NLS2014001  
January 17, 2014

**Subject:** 60-Day Response to Request For Additional Information Regarding License Amendment Request To Adopt National Fire Protection Association Standard 805 Cooper Nuclear Station, Docket No. 50-298, DPR-46

60-Day Response to Cooper Nuclear Station  
Request For Additional Information Regarding  
License Amendment Request To Adopt  
National Fire Protection Association Standard 805

Figure 1: Main Control Room Abandonment Tree

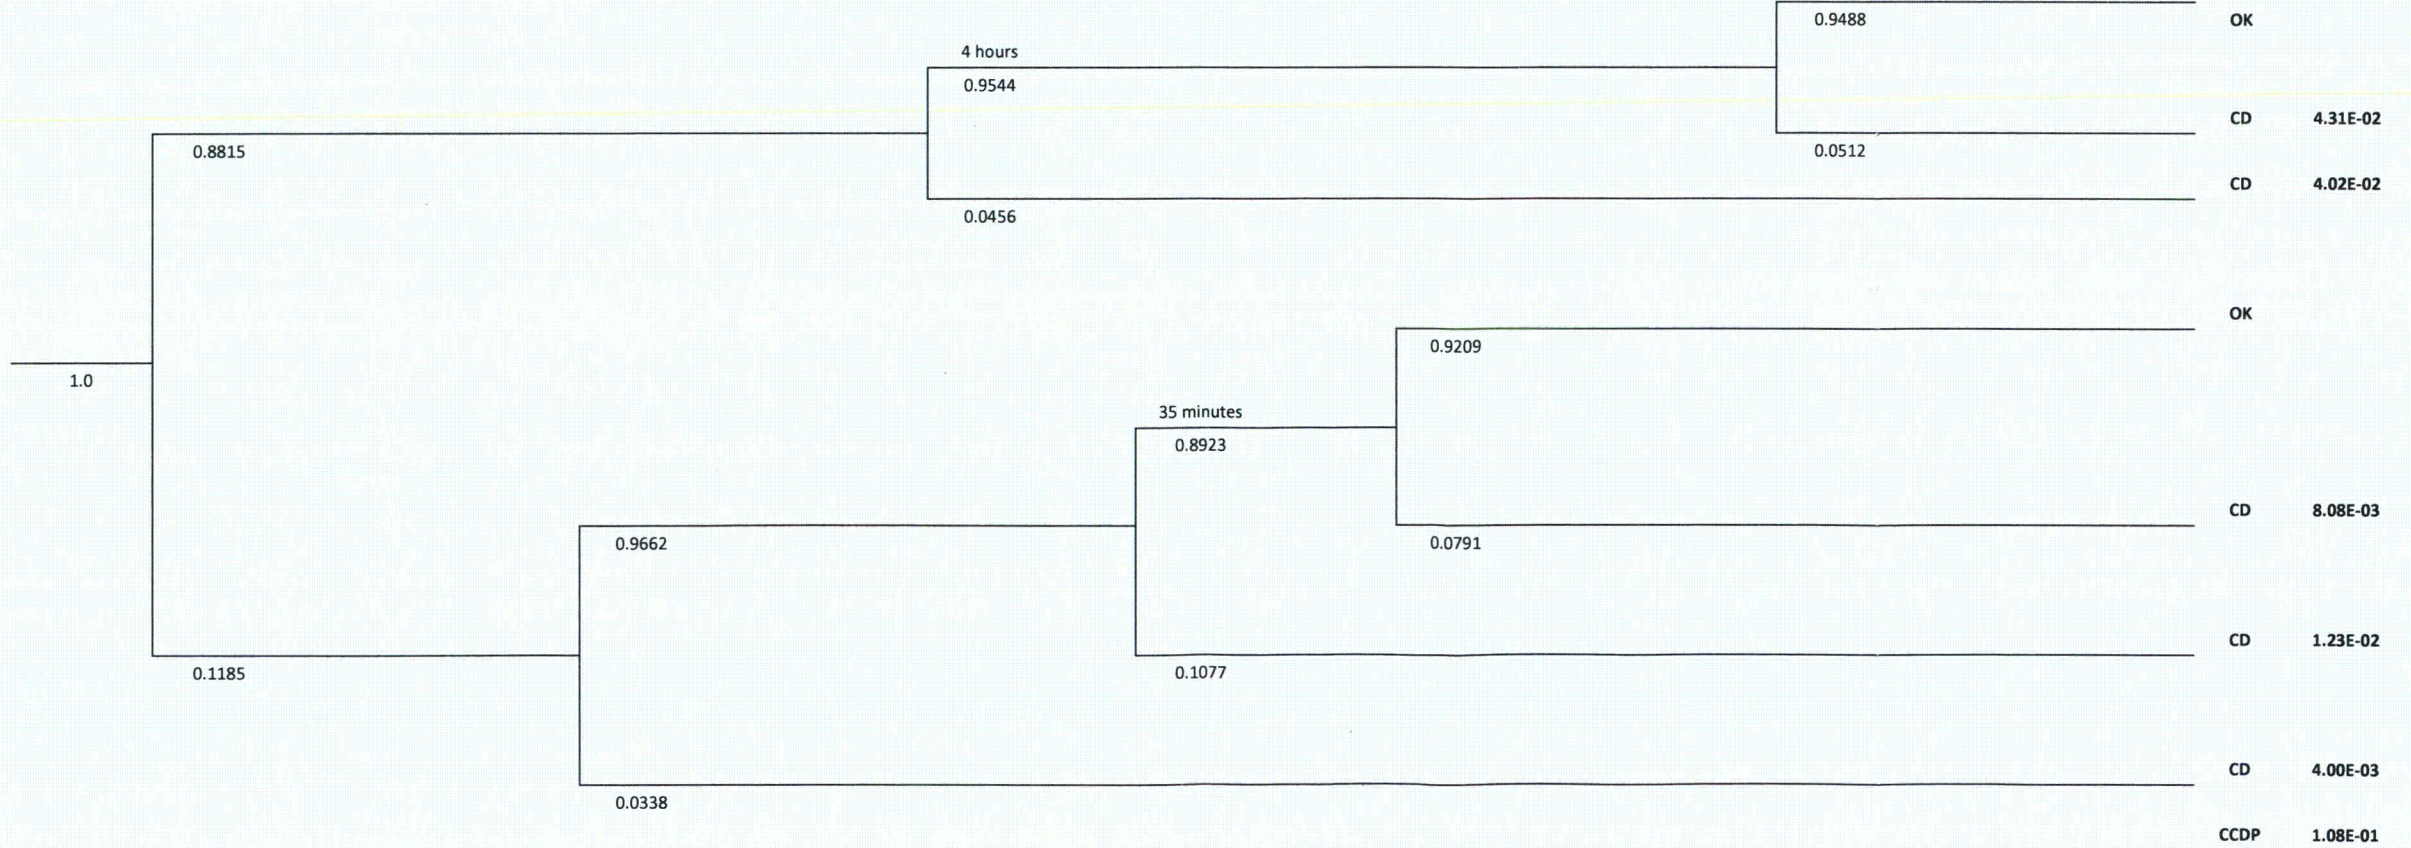
*In a letter dated January 14, 2013 (ADAMS Accession No. ML13018A006) the licensee responded to PRA RAI-14 and provided justification of a value of 0.1 to represent the failure to reach safe shutdown using alternate means. The justification largely consists of a qualitative argument that the feasibility assessment and the seven considerations identified in NUREG-1921 are addressed for alternate shutdown. A quantitative assessment of the failure of alternate shutdown is not presented. It appears from the response that this single HEP value of 0.1 is used for every MCR abandonment scenario.*

- a. *Describe whether there are any values other than 0.1 used to characterize the HEP following MCR abandonment and whether the 0.1 also represents the CCDP. In addition, describe the CLERP.*

- b. *If any values other than 0.1 are used, (e.g., 1.0), provide the other values, a characterization of the scenarios where these values are used, and a summary of how each value is developed. This information should include explanations of how the following scenarios are addressed.*

- a. In the analysis for the LAR submittal, only the value of 0.1 was used for MCR abandonment fire scenarios. The MCR abandonment CCDP/CLERP of 0.1 was characterized by incorporating both the HEP for shutdown from outside the MCR and system/train failures into the CCDP/CLERP. The MCR abandonment value for CLERP was taken to be equal to the MCR abandonment value for CCDP.
- b. In response to this RAI, the MCR abandonment analysis was revisited. The re-analysis for MCR abandonment addresses human and equipment performance in lieu of the screening approach presented in the LAR. The same procedure is used for all fires leading to MCR abandonment; whether abandonment was due to loss of command and control or loss of MCR habitability. The re-analysis identified actions at the primary control station (PCS), local actions (actions away from the PCS), and equipment reliability/availability.

The ASD procedure uses Reactor Pressure Vessel (RPV) injection with High Pressure Coolant Injection (HPCI) as the preferred safe shutdown path with Residual Heat Removal (RHR) pump D in Suppression Pool Cooling (SPC). Should HPCI injection fail, RHR pump D is available for Low Pressure Coolant Injection (LPCI) injection providing the RPV is depressurized. A MCR abandonment tree was developed for ASD as shown in Figure 1 below.

The ASD HEPs for all actions, both at the PCS and away from the PCS, were developed using the Human Reliability Analysis (HRA) Calculator and the methods in NUREG-1921. HEPs for MCR abandonment scenario actions are provided in Table 1 below. Equipment reliability/availability was determined for ASD systems and is provided in Table 2 below. The incorporation of ASD human actions and equipment performance into the model resulted in a MCR abandonment CCDP of approximately 0.108 as shown in the MCR abandonment tree (Figure 1). MCR abandonment CLERP was again taken to be the same as CCDP.
